Product Change Notice (PCN)

Subject: Addition of assembly site for Renesas SRAM TSOP products

Publication Date: 7/27/2022

Comparison table: Product of current source of assembly (ATM) vs Product of additional source of assembly (GTK)

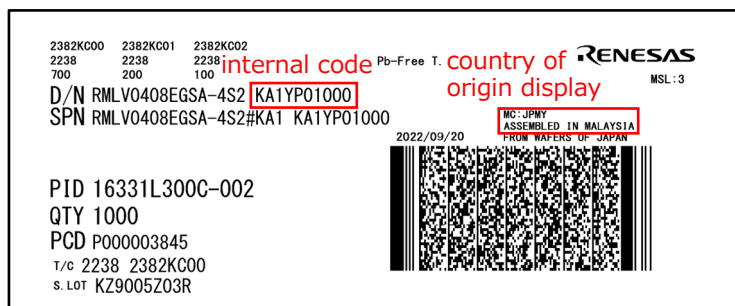
Item		Product of current source of assembly (ATM)	Product of additional source of assembly (GTK)
Assembly line		Amkor Technology Malaysia Sdn. Bhd. (Malaysia)	Greatek Electronics Inc. (Taiwan)
Country of origin display		MALAYSIA	TAIWAN
Assembly Material	Lead frame material	Cu	Cu
	Inner lead pattern	Current pattern (ATM original pattern)	Different from ATM pattern (GTK original pattern)
	Outer lead pattern	Current pattern	Compatible with ATM pattern
	Lead plating	Sn (pure tin)	Sn (pure tin)
	Die bonding	Epoxy paste	Epoxy paste
	Wire bonding	Au	Au
	Mold	Epoxy resin (Halogen-free)	Epoxy resin (Halogen-free)
Die thickness		280µm	254µm
Final test line		Powertech Technology Inc. (Taiwan)	←
Packing specification		Current specification	←
Moisture-proof performance		MSL 3	←
Shipping label		Current specification	No change in format (Changes in internal code and country of origin)

Although there are differences in the inner lead pattern and die thickness, these do not affect the compatibility of electrical characteristics (DC/AC).

Product of current source of assembly (ATM)

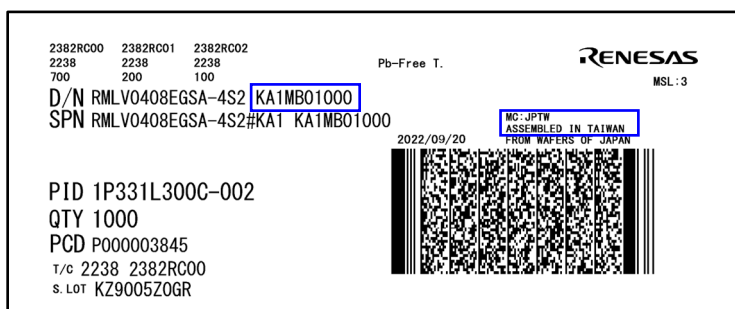
Shipping label specification:

- Label format itself is unchanged.
- Written specifications: "internal code" and "country of origin display" are changed. See below for example.
